BID # 26.006
Tennyson High School Locker Rooms/Gym Floor Upgrades

Addendum #3 - May 15, 2026

ASI #047.1

Gym Court Striping ~~& Basketball Backboards~~

A-G2.2

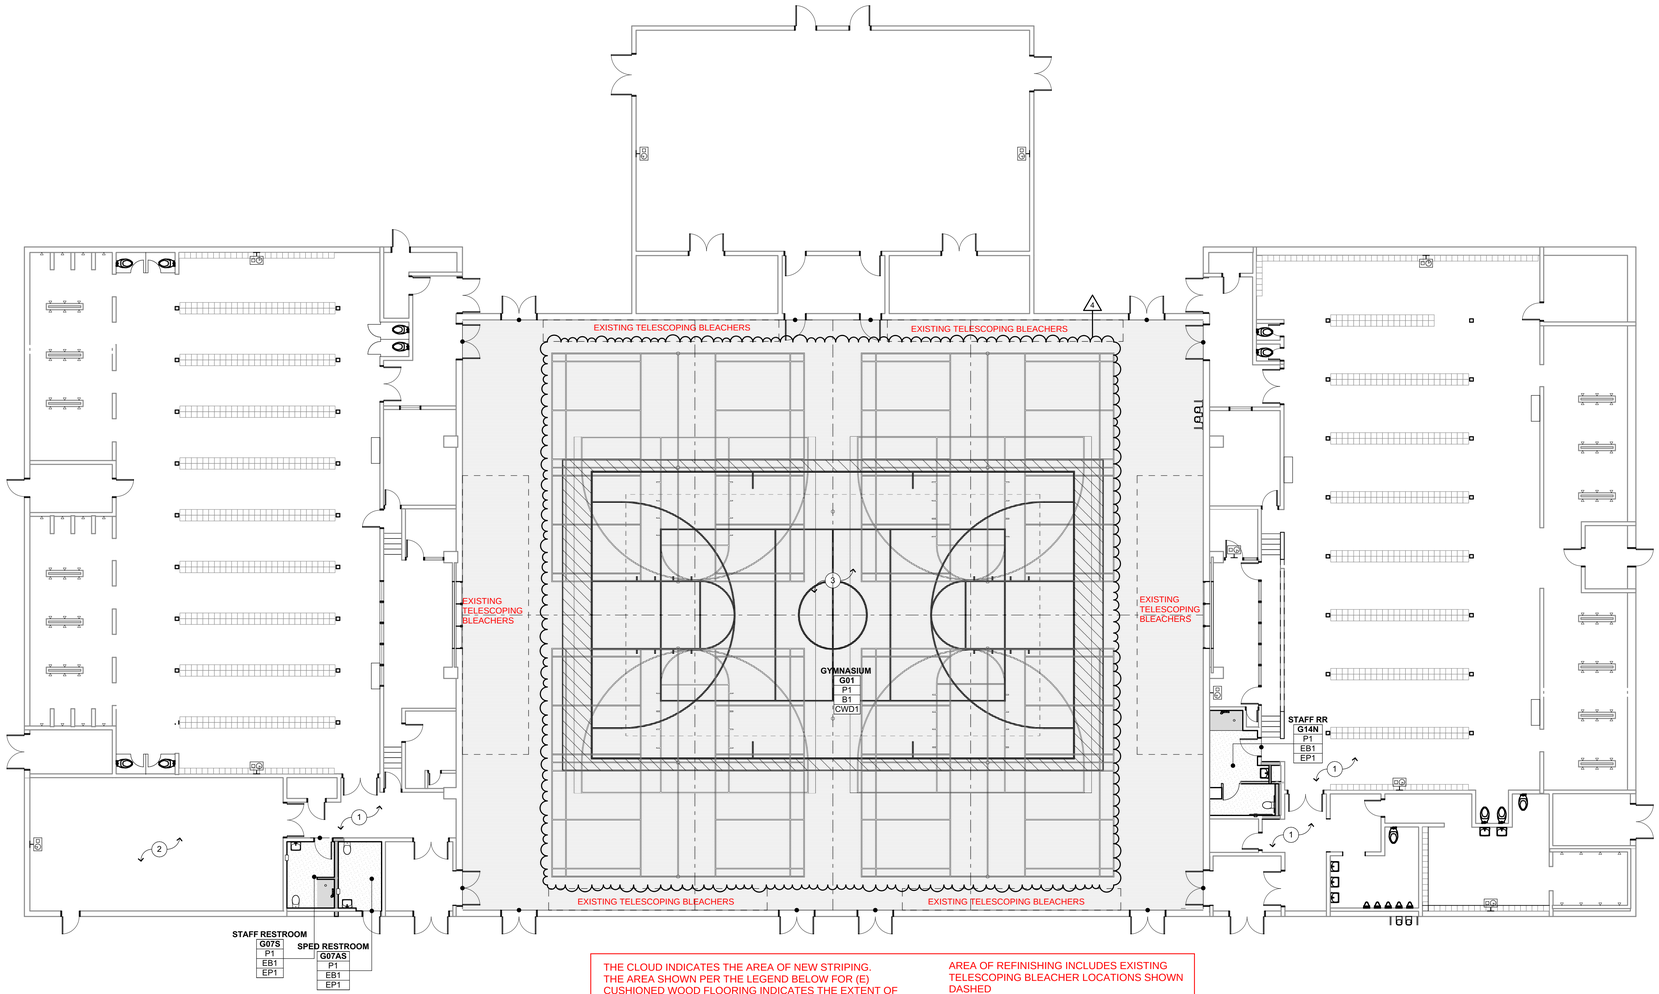
THE CLOUD INDICATES THE AREA OF NEW STRIPING. THE AREA SHOWN PER THE LEGEND BELOW FOR (E) CUSHIONED WOOD FLOORING INDICATES THE EXTENT OF FLOORING TO BE REFINISHED PRIOR TO STRIPING.

AREA OF REFINISHING INCLUDES EXISTING TELESCOPING BLEACHER LOCATIONS SHOWN DASHED

DESCRIPTION
~~Pending DSA approval.~~
~~Install new basketball backboards per the attached.~~
~~Backboards to be Porter 917 Series. Forward Fold Center Strut, coordinate with Porter Rep this is basis of design.~~
See attached striping plans.
Provide shop drawing submittal for court striping.
~~Provide shop drawing submittal for the basketball equipment~~.
~~Provide updated submittal for badminton, volleyball and wall pads product data and shop drawings as required for new layouts per existing specifications and basis of design~~.
Use vector file provided in ASI-041 for center court logo.
